Reply to Reviewers' Comments

Reply to Reviewer #1

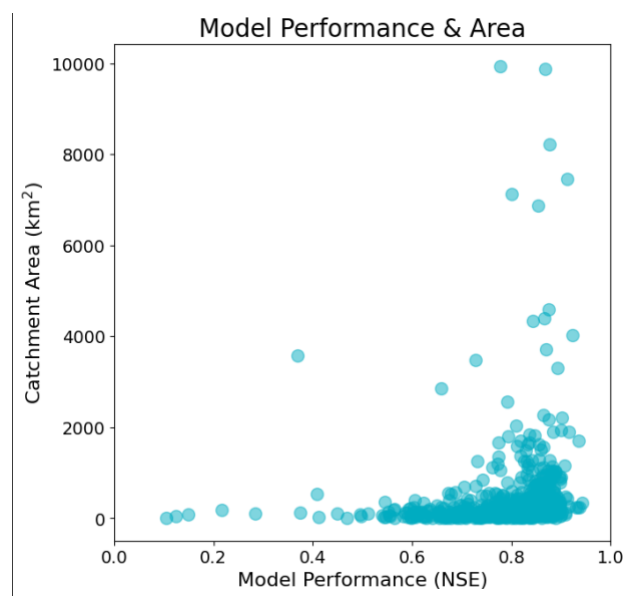
Line 344. There are a few catchments with NSE lower than 0.6; therefore, there is not enough information to support this statement.

We thank the Reviewer for this comment. We acknowledge that a small number of catchments have NSE values lower than 0.6. To ensure that our statement is properly supported, we will revise Figure A by removing the log-transformed x-axis (as shown below). We will clarify this point in the manuscript to ensure the interpretation is properly supported.
